Administrative Committee for the TIR Convention, 1975

Amendment proposals to the Convention: Vehicles with sliding sheets

Note by the secretariat

Amendment proposals for adoption by the Administrative Committee for the TIR Convention

Sketch No.10.2

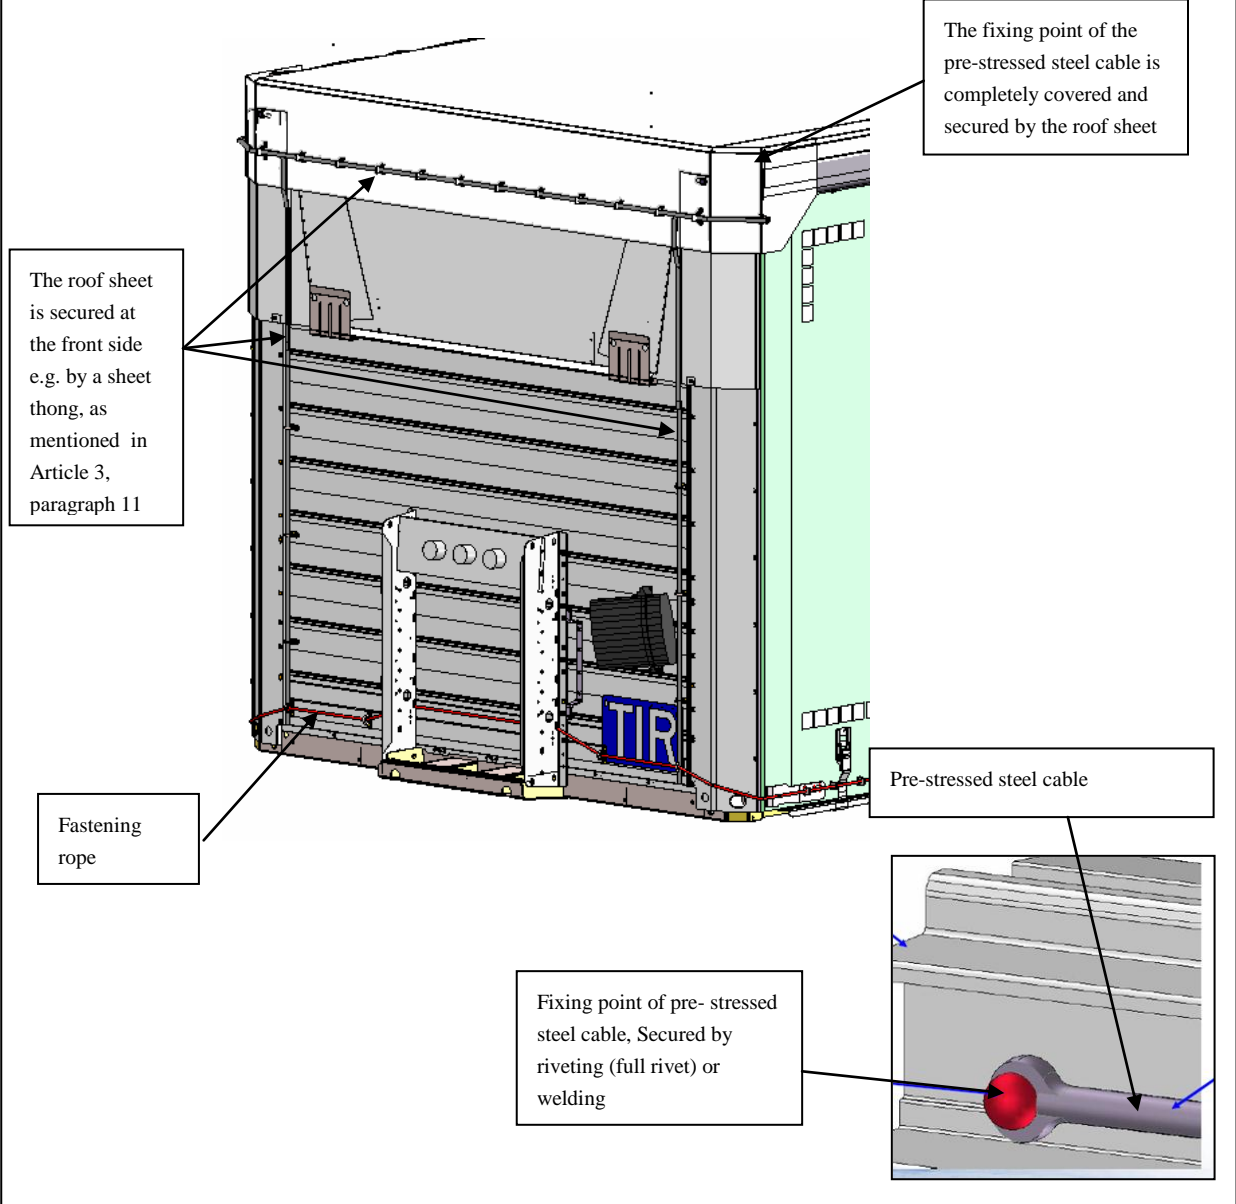
The sliding roof sheet shall overlap with the solid part of the roof at the front side of the container, so that the roof sheet cannot be pulled over the top edge of the upper cantrail
